**GOVERNMENT OF THE DISTRICT OF COLUMBIA
DEPARTMENT OF TRANSPORTATION**

MEMORANDUM

SUBJECT: **Zoning Commission Case No. 13-14** - McMillan Reservoir - 2501 First Street, NW

Figure 2 Medical Office Parking Garage (Gorove/Slade; altered by DDOT)

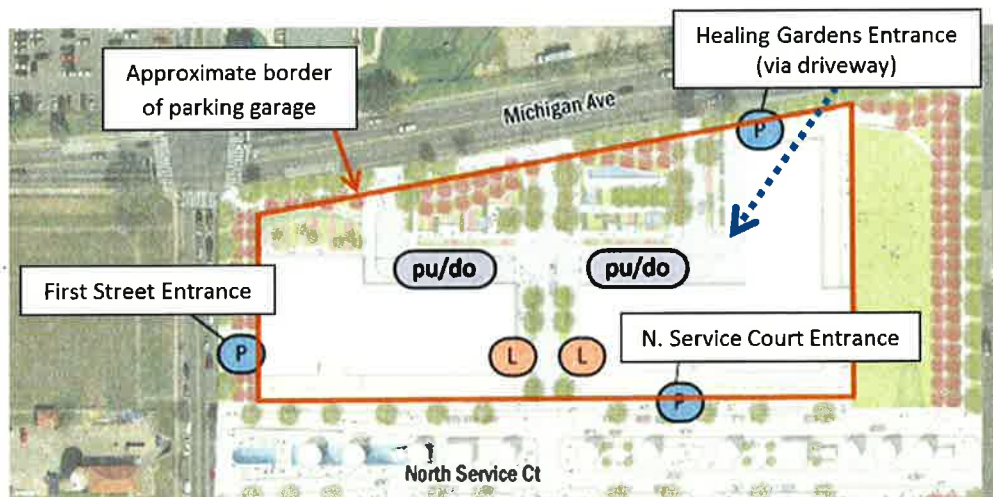
- The First Street NW entrance for the medical office parking garage has the potential to cause operational problems if not properly managed;
- As currently designed, the proposed site access plan inhibits some travel movements and forces site trips to make turn movements in locations that lead to increased travel delay;

It is important to note that the parking garage beneath Parcel 1 is one single facility. The parking garage extends under Half Street. While the Applicant has segregated the three parking garage access points by user type, the entrances could and should be used by any of the site users. To underscore this point, this report refers to the entrances as the First Street, Healing Gardens, and North Service Court entrances.

- Commit to improving circulation and operations by instituting two-way operations on a portion of the Healing Garden driveway, installing signage in the garage such that egress in a specific direction is assigned to a certain access point, and institute trip caps for some medical office building parking garage driveways;

Figure 3 Mode Split Assumptions (Source: Gorove/Slade)

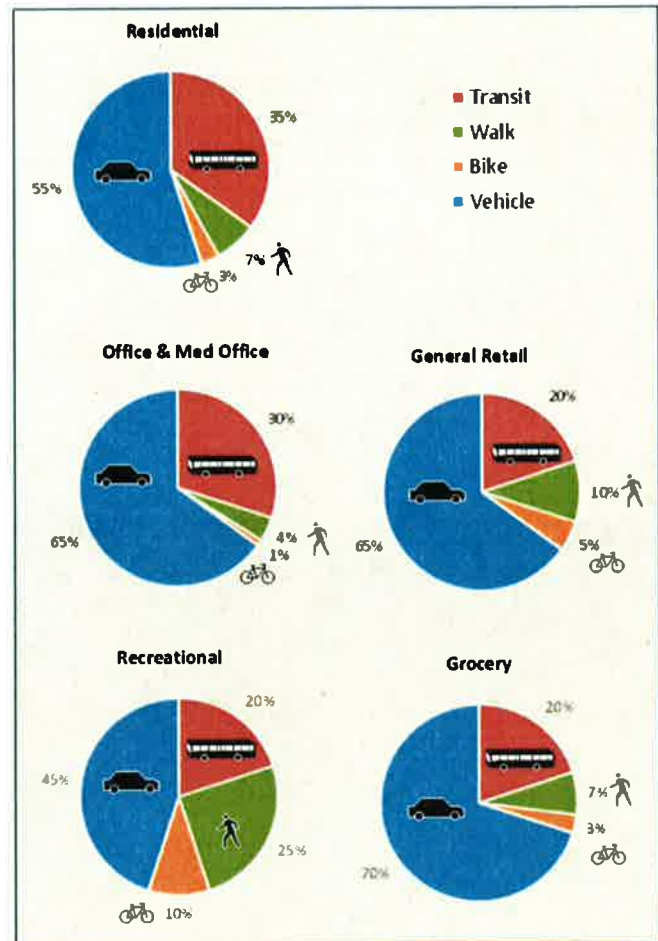
DDOT generally finds the use of these ITE codes appropriate, but notes the lack of dependable information on trip generation for medical office uses in urban contexts. The data points associated with ITE Code 720 used to inform a predictive model contain significant variability in the amount of trip generation. This variability becomes even more pronounced as the facility size increases. Additionally, data is only available for a few medical office facilities greater than 90,000 square feet – approximately 10% of the size of the subject medical office facility. It is reasonable to expect lower trip generation rates from larger facilities, especially in urban contexts, due to the economies of scale available to patients making multiple appointments for the same visit. The limited data available from ITE Code 720 does not capture this dynamic. Accordingly, ITE Code 720 likely over-predicts the number of trips expected to be realized from the medical office component.
